# Access Compliance Report

## Public Rights-of-Way

Intersection ID: 44003	Main Street: FELICITY_CT	Cross Street: ELROSE_PL	Location: SE
ADA ID: 1999A7BD4A6D	Ramp Type: BlendTrans1	Initial Pass/Fail: Fail	Overall Compliance: No
		Severity Score: 33.75

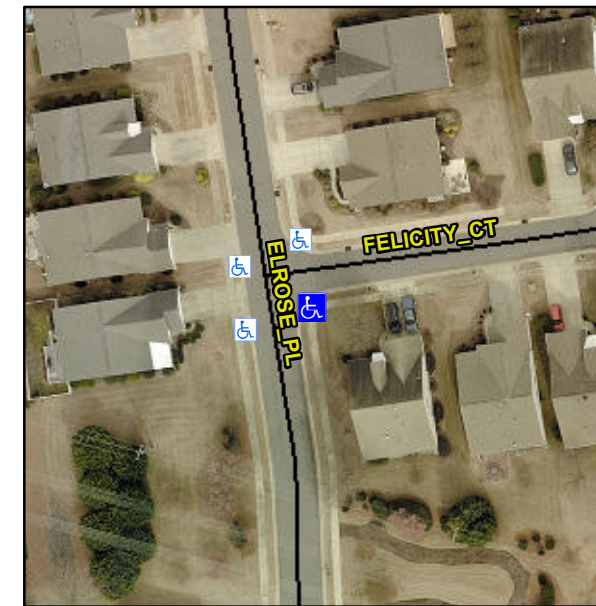
**Not Found, R304.5.1, R304.5.3**

Compliance	Description	Data	Compliance	Description	Data
N/A	Ramp Length (in)	47.0	Yes	BlendTrans Slope (%)	3.3
No	Ramp Width (in)	47.0	No	BlendTrans XSlope (%)	7.5
N/A	Flare Type LT	N/A	N/A	Flare Type RT	N/A
N/A	Flare Slope LT (%)	N/A	N/A	Flare Slope RT (%)	N/A
N/A	Flare Traversable LT?	N/A	N/A	Flare Traversable RT?	N/A
N/A	Landing Length (in)	N/A	N/A	DWS Provided?	N/A
N/A	Landing Width (in)	N/A	N/A	DWS Contrast?	N/A
N/A	Landing Slope (%)	N/A	N/A	DWS Length (in)	N/A
N/A	Landing X Slope (%)	N/A	N/A	DWS Full Width?	N/A
N/A	Landing Curb? (Y/N)	N/A	N/A	DWS Offset (in)	N/A
N/A	Shared Landing?	N/A			
N/A	Gutter Ponding?	N/A	N/A	Gutter Slope (%)	N/A
N/A	Gutter Lip Ht (in)	N/A	N/A	Gutter X Slope (%)	N/A
N/A	Painted X Walk1?	No	N/A	Painted X Walk2?	No
	X Walk 1 Direction	To N		X Walk 2 Direction	To W
	X Walk 1 Width (in)	N/A		X Walk 2 Width (in)	N/A
	X Walk 1 Slope (%)	2.2		X Walk 2 Slope (%)	5.3
	X Walk 1 X Slope (%)	7.7		X Walk 2 X Slope (%)	0.9

N/A	Ramp inside XWalk1?	N/A	N/A	Ramp inside XWalk2?	N/A
	Road Slope (%)	4.7		Clear Space?	N/A
	Road X Slope (%)	5.9	N/A	Clear Space to XWalk (in)	N/A
N/A	Any Obstructions?	N/A	N/A	Storm Grate/Utility Hazard?	N/A
	Obstruction Type			Storm Grate/Utility Type	
		N/A			N/A
			Yes	Surface Condition? (G/P)	Good
			No	Curb Slope (%)	16.3

**Remove & Replace Curb Ramp With Two New Directional Ramps or Equivalent.**
